Your Reference: MP 11_0048
Our Reference: NCA/5/2011
Contact: Kate Lafferty
Telephone: 9806 5393
Fax: 9806 5901

**Major Project 11_0048 – Residential Development – Buildings 6, 9, 10 & 17
61 Mobbs Lane - Epping - Channel 7 Site (Epping Park)**

Plan View

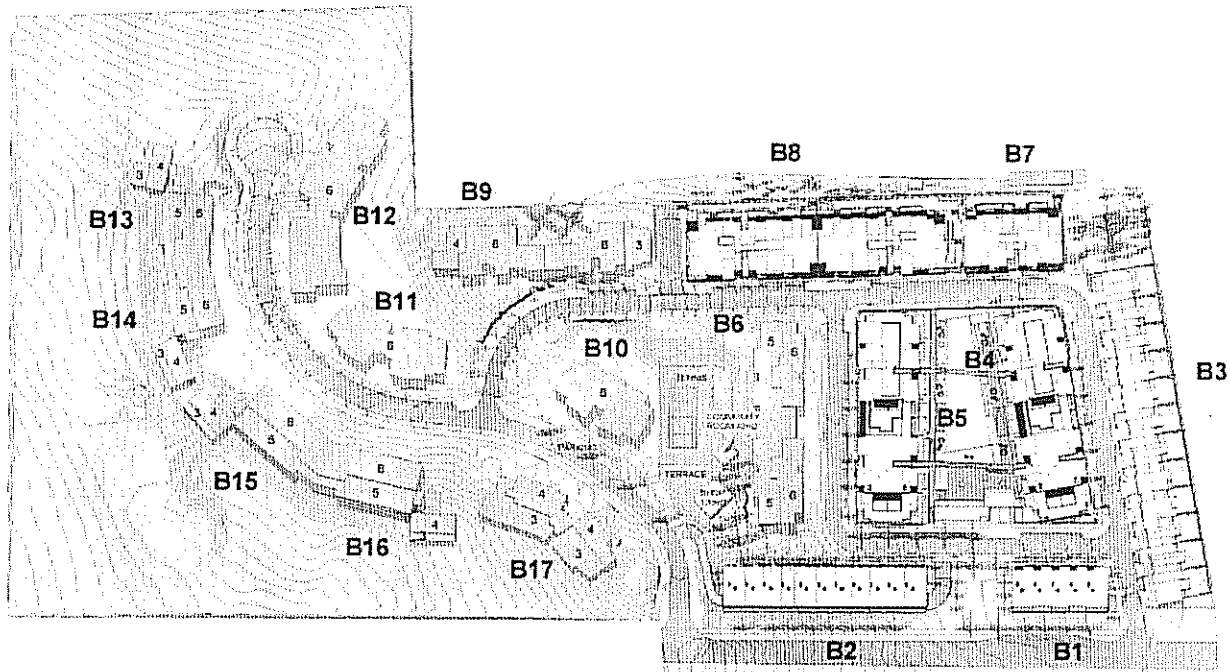
Concern is raised with the height of Buildings 6, 9 and 17 and whether they comply with the height restrictions contained within the Concept Plan. It is difficult to properly assess the heights as no natural ground levels have been provided on the plans and the levels on the submitted survey cannot be ascertained. The comments are therefore based upon the architectural elevations and sections provided.

The approved height distribution of Building 6 indicates a 6 storey element on the northern elevation and a 5 storey element on the southern elevation. The plans submitted do not indicate the stepping of these storeys.

The approved height distribution of Building 9 indicates a 6 storey building with a 3 storey element to the north-east and a 4 storey element to the south-west. The plans submitted do not indicate the correct stepping of these storeys as the building is partially 5 storeys to the north-east and partially 6 storeys to the south-west.

The approved height distribution of Building 17 indicates 3 storeys facing the Mobbs Lane frontage with 4 storeys at the rear. The 3rd storey element is to wrap around to the west however appears as a 4 storey element on the submitted architectural plans.
